**Re: Ontario Power Generation Inc.  
2017-2021 Payment Amounts  
Ontario Energy Board File Number EB-2016-0152**

**OEB Staff Interrogatories  
Ontario Power Generation Inc. (OPG)  
2017-2021 Payment Amounts  
EB-2016-0152  
September 26, 2016**

Ref: Exh A1-3-3 Chart 1

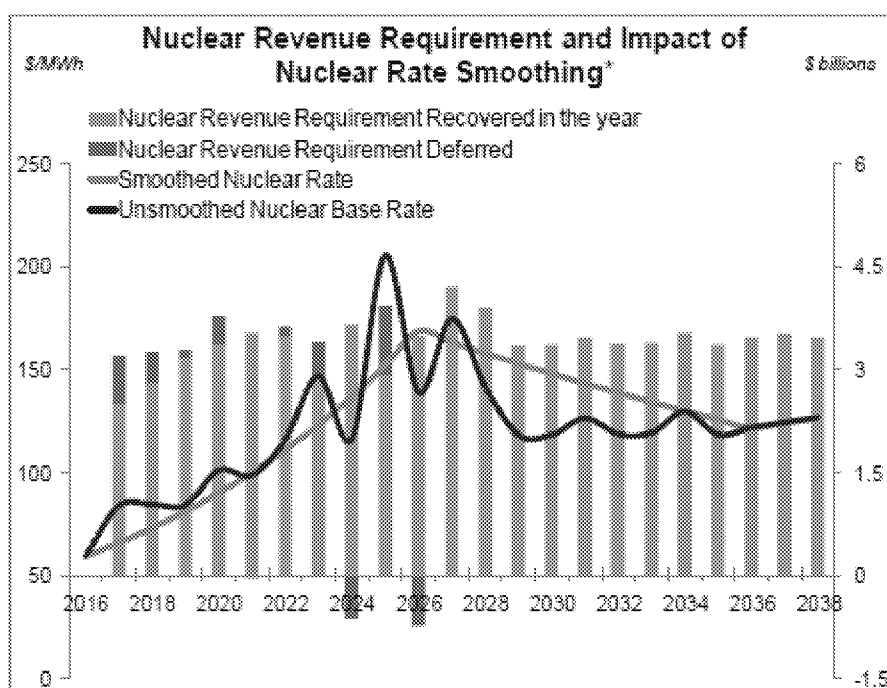
The 2016-2018 business plan states that nuclear rate smoothing will moderate price spikes during DRP and eventual Pickering closure period, and the following graph is provided in the business plan.
